**T.Y. LIN INTERNATIONAL**  
THE STAMPED DOCUMENTS ARE HEREBY:

NO.	DATE	REMARKS	BY
REVISIONS			
		<b>CASCO BAY STEEL STRUCTURES</b> ONE WALLACE AVENUE PHONE: 207-780-6722 SOUTH PORTLAND, ME 04106 FAX: 207-780-6726	
STRUCTURE <u>BENMONT AVE. (TH-7) (URBAN MINOR ARTERIAL)</u>			
LOCATION <u>TOWN OF BENNINGTON, VERMONT</u>			
PROJECT NO. <u>BRIDGE NO. 57 PROJECT NO. BR 1000(16)</u>			
ENGINEER <u>STATE OF VERMONT AGENCY OF TRANSPORTATION</u>			
CUSTOMER <u>ALPINE CONSTRUCTION</u>			
ITEM <u>ERECTION PLAN</u>			
SURFACE PREP. <u>OPEN HOLES</u>			
PAINT _____			
APPROVAL	DRAWN <u>FM</u>	12-3-14	SHEET NO. <u>E1</u>
SHOP	CHECKED <u>FM</u>	1-6-15	JOB NO. <u>605</u>

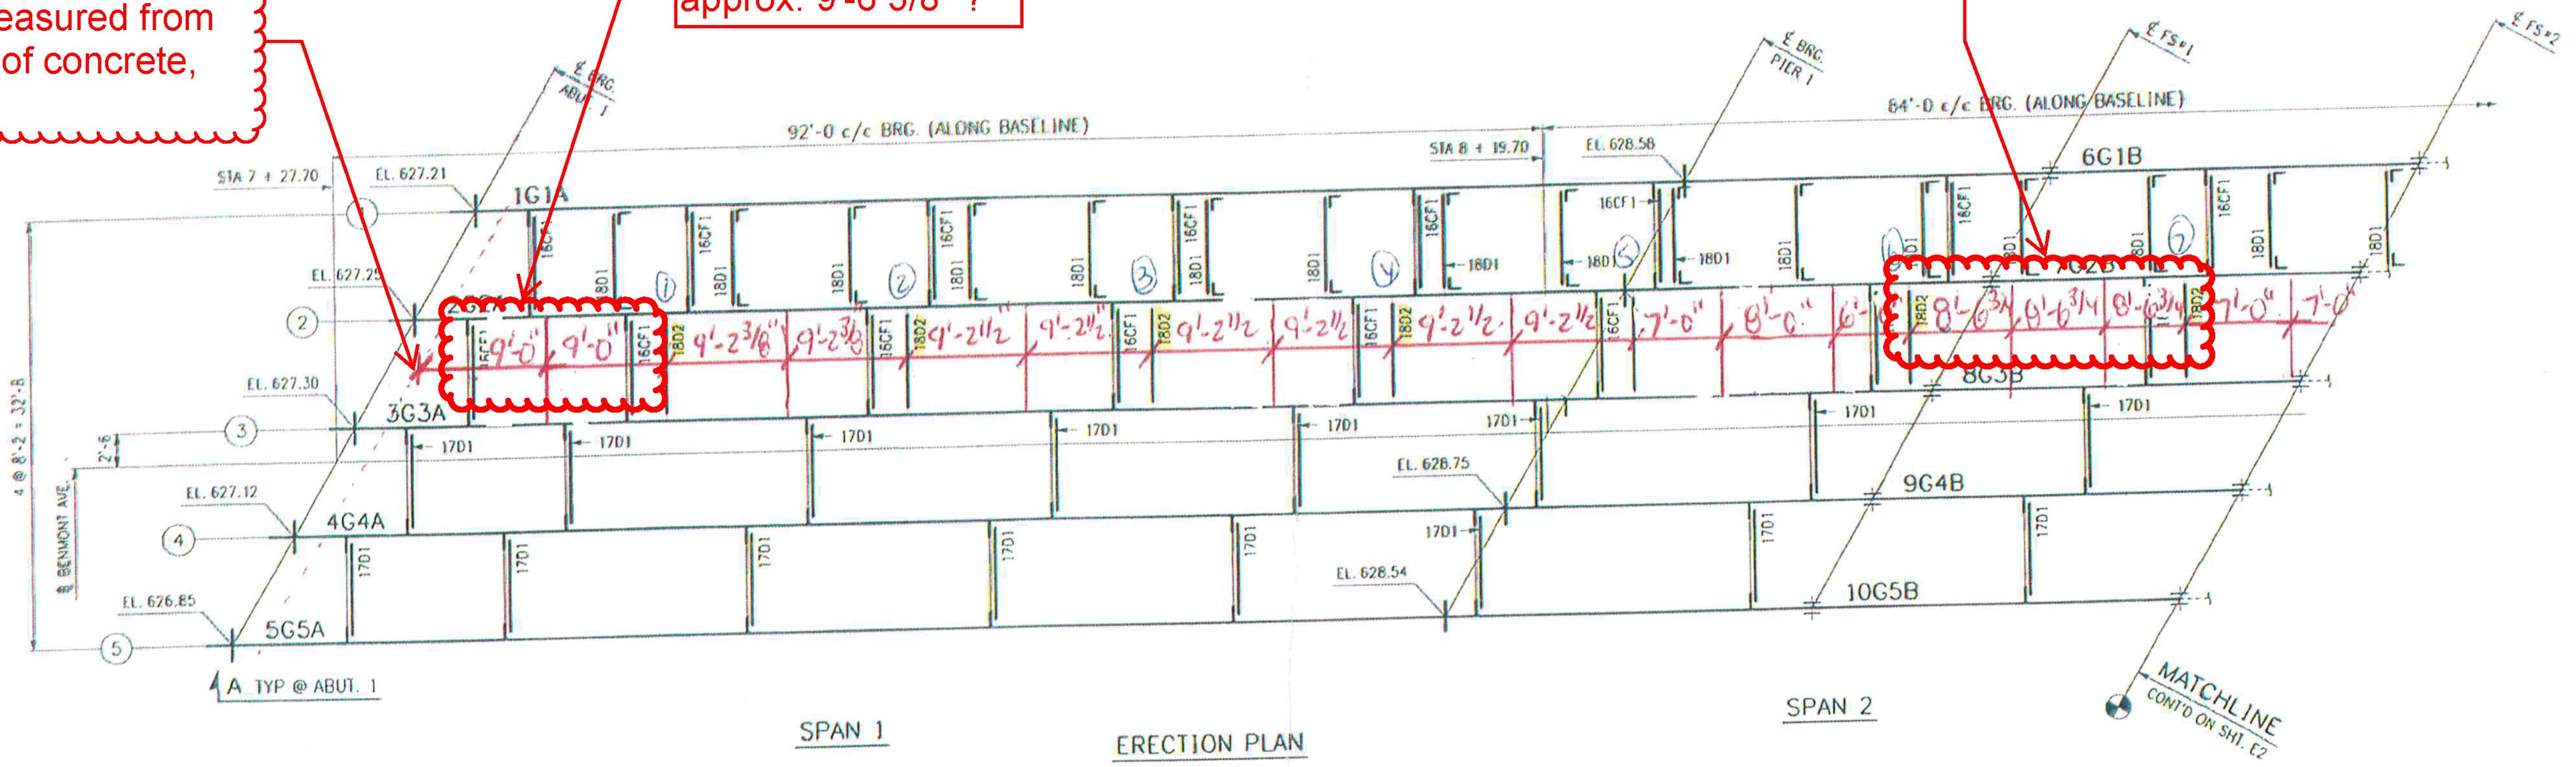
Assume proposing to measured from face of concrete, OK.

Should this be 2 @ approx. 9'-6 5/8" ?

Should this be 3 @ approx. 7'-0" ?

Ok with general spacings as indicated. Did find some minor discrepancies with summations for spacings in comparison to locations of utility supports shown in approved shop drawings. Just check/verify spacings as noted.
